Towing Package Retrofit

Classification	Parts and Accessories Bulletin	Section/Group	90 - Accessories	Country/Region	All
Year	All	Model	Model X	Version	All

Figure 4 (Diffuser Revision A)

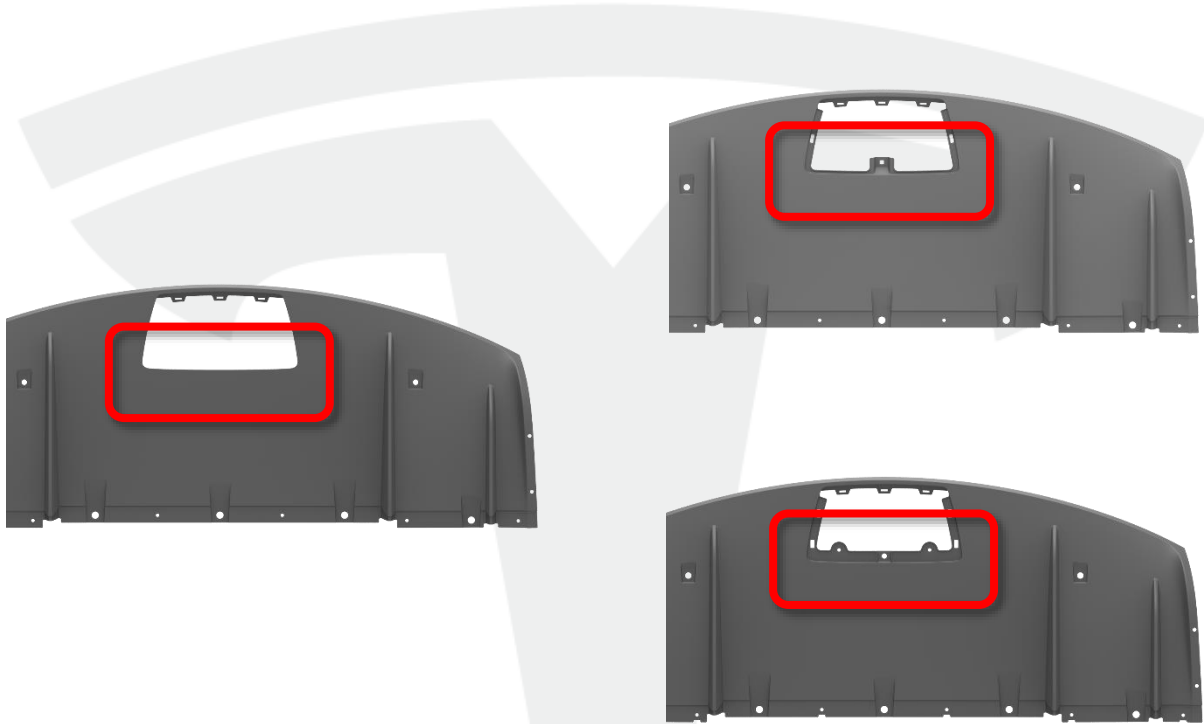
1. Remove the rear bumper assembly (refer to Service Manual procedure 10013102).
2. Determine if the rear diffuser should be replaced (Figure 4 and Figure 5):
 - If the diffuser is part number 1058356-00-A: Discard the diffuser and access cover, and then do the following:
 - a. Replace the rear diffuser panel with part number 1058356-00-C (refer to Service Manual procedure 12030802)
 - b. Replace the tow hitch access cover with part number 1058357-00-D.
 - If the diffuser panel is part number 1058356-00-B or later: Continue this procedure.
